Re: FortisBC Energy Inc. (FEI)

#### 2022 Long Term Gas Resource Plan (LTGRP) - Project No. 1599324

Response to the Residential Consumer Intervener Association (RCIA) Information Request (IR) No. 1

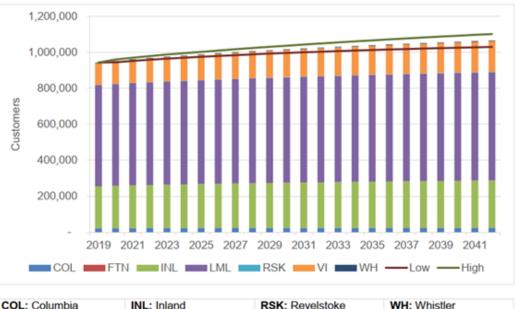
4 On page 3-16 of its Plan, FEI states: "The unique physical, chemical, interchangeability, 5 and utilization characteristics when compared to conventional natural gas may limit 6 hydrogen gas as a drop-in replacement fuel, beyond a percentage blend expected to be 7 in the concentration range of 2 to 20 percent by volume. As hydrogen is less dense, it 8 will require somewhat larger pipes and more compression to deliver similar amounts of 9 energy."

10 On page 3 of Appendix D-3 of its Plan, FEI states: "Hydrogen has a heating value of 11 12.1 MJ/m3. As a result, if hydrogen is directly substituted for natural gas, around three 12 times the volume of hydrogen must be delivered to customers to meet the same energy 13 delivery of unit volume of natural gas."

26 As outlined in the technical analysis discussion provided here using the same approach that 27 was used in developing Table D3-1 in Appendix D-3 of the Application, and carefully selecting 28 simple pipe segments and setting conditions where the limiting constraint remains consistent in 29 each case, a 20 percent blend of hydrogen would result in a reduction of energy capacity of approximately 7 percent in both systems compared to a 0 percent hydrogen scenario. However, 30 31 there are a variety of parameters that may constrain or define pipeline capacity based on the 32 operating conditions and configuration of the system. It can be misleading to apply a 33 generalization of changes in capacity to transmission or distribution systems. Increasing the 34 hydrogen content in a pipeline tends to decrease the energy delivery capacity but increase the 35 resulting gas velocity and volumetric throughput. While a pipe flowing natural gas with no hydrogen may be constrained by the minimum delivery pressure at the delivery point, a blend 36 37 of, 20 percent hydrogen for example, could cause the pipe to be constrained instead by high 38 gas velocity. Table D3-1 in Appendix D-3 of the Application illustrates this difference with a

1 comparison (using 100 percent hydrogen) defining the pipeline energy delivery capacity based 2 on different limiting constraints. Gas properties used in gas flow equations can change with 3 hydrogen blends as well. Transmission systems will operate over a broader range of pressure 4 (spanning thousands of kPa) than in distribution systems (spanning hundreds of kPa), and, as a 5 result, shifts in constraints as described above may be more likely to occur, and the effect of 6 variation in physical properties affecting flow may contribute to some small changes in capacity 7 in a transmission system that would not be noticed in a distribution system. Additionally, 8 distribution systems are typically very interconnected, and the system itself does not have 9 overall capacity that can be easily quantified. This is because capacity constraints are localized 10 and sensitive to the distribution of demand in the network, so a change in blend percentages 11 may trigger capacity constraints in some systems more than others.

Figure 9-2: GHG Emission Reductions (End Use) Modelled for the Reference Case and Alternate Scenarios – Residential, Commercial and Industrial Customers

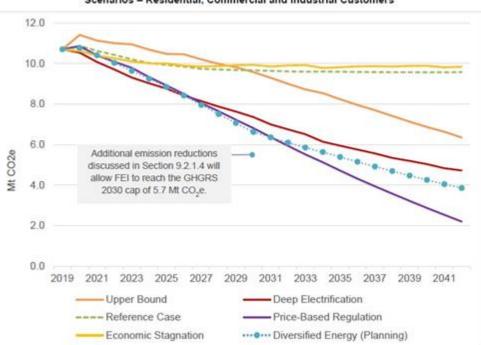
8.1 Explain whether the Diversified Energy (Planning) Scenario requires the development of Pillars 3 and 4 of the Clean Growth Pathway in order to meet the GHG Reduction Standard emissions cap.

- 26
- 27
- 28
- 298.3Provide a version of Figure 9-2 with the GHG emissions reductions from the30Diversified Energy (Planning) scenario but without any contribution from Pillars 331and 4 of the Clean Growth Pathway. If FEI is unable to model these emissions32reductions, then describe the approximate reductions in relation to the other33scenarios shown in Figure 9-2.
- 3435 <u>Response:</u>

Figure 9-2 in the Application, and cited in the preamble, already provides the scenario described in the information request as it represents GHG emissions reductions from residential, commercial and industrial customer groups. These reductions are achieved through Pillars 1 and 2 only. Pillars 3 and 4 of the Clean Growth Pathway are not factored into Figure 9-2.

3 At page 6 of Appendix B-3 of its Plan, FEI provides Figure B3-5:

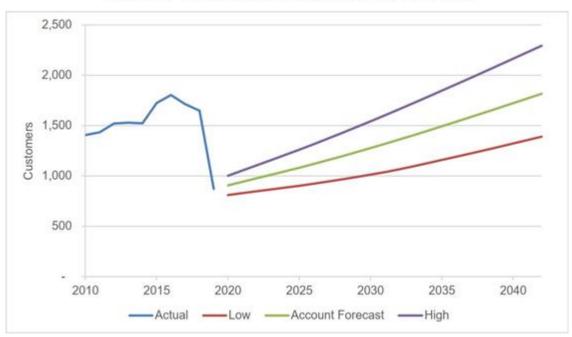
6 7 9.1 Please comment on and explain the apparently sudden change in the trend displayed on Figure B3-5 (i.e. from a sharp decrease between 2016 and 2019, to an increasing trend in the forecast period).

15 As described in Section 1.1.1.2 of Appendix B-1, and to offset the impacts of rate-switching on 16 the customer forecast, customers in Rate Schedules 3 and 23 were forecast as a single group. 17 The resulting customer forecast was then proportioned between the two classes based on the 18 2019 year-end actual customer count. Therefore, because of the recent upward trend in Rate 19 Schedule 3 customers (illustrated in Figure B3-4) and the upward trend in Rate Schedule 23 20 customers up to 2016, this method results in a forecast upward trend for Rate Schedule 23 21 customers.

At page 9-4 of its Plan, FEI provides Figure 9-1:

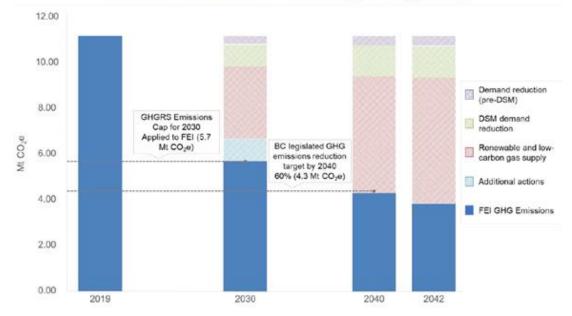
16.1 Provide a spreadsheet of all measures included in the Diversified Energy (Planning) scenario – High DSM setting, organized by program and program area, showing the annual gas savings, GHG emissions reductions, measure life, persistence, NPV gas savings, and NPV emissions reductions.

Please refer to Attachment 16.1 for a live spreadsheet of all measures in the DEP Scenario – High DSM setting, organized by program area and measure for the base year 2020 and milestone years 2030 and 2042. Note that the CPR and hence the LTGRP DSM scenarios look at customer sectors (program area) and measures. DSM Expenditure Plans are where programs are developed and listed.

For each measure, the list illustrates annual gas savings, GHG emissions reductions, measure life, NPV gas savings, and NPV emissions reductions. As part of the LTGRP planning process, measure savings were assumed to reflect an average of both measure persistence (i.e. how many measures stay installed for the measure life) and savings persistence (i.e. how the savings degrade over the measure life). Thus, the persistence for all measures is assumed to be 100 percent.

#### Figure 9-7: Cumulative Effective Rate Impact (2022 - 2042) - Residential RS 1, Avg. UPC 60 GJ

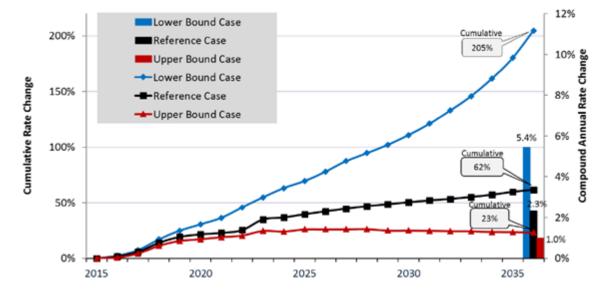
- 8 35.1 Confirm whether the capital expenditures factored into the analysis on effective 9 rate impacts includes the capital expenditures necessary to accommodate 10 increasing proportions of hydrogen blended into the gas stream, such as 11 dedicated H2 pipelines or H2 separation facilities at Huntingdon, Tilbury, and 12 Coquitlam (Woodfibre LNG).
- 1335.1.1If not confirmed, explain the relevance of the rate impact analysis14considering the potential magnitude of the required capital expenditures15to facilitate H2 blending into FEI's system.
- 16

- 35.3 Explain whether the Reference Cases in each of Figure 9-7 and 8-9 are approximately equivalent or whether there are substantial differences.
  - 35.3.1 If they are substantially different, explain in what ways they are different.

8 Figures 9-7 to 9-10 in the Application show the total bill impact per rate schedule including
9 delivery, cost of gas, storage and transport, and carbon tax. Figure 8-9 of the 2017 Long Term
10 Gas Resource Plan only shows the delivery rate impact. To be responsive, FEI has included

1 On page 212 of its 2017 Long Term Gas Resource Plan, FEI provides the overall rate 2 impacts for three scenarios:

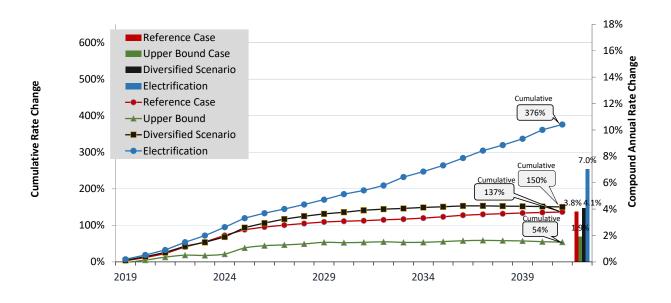
35.2 Provide the indicative rate impacts for all rate schedules (combined), similar to Figure 8-9 from the 2017 LTGRP.

11 the delivery rate impact of the 2022 LTGRP similar to Figure 8-9 from the 2017 LTGRP.
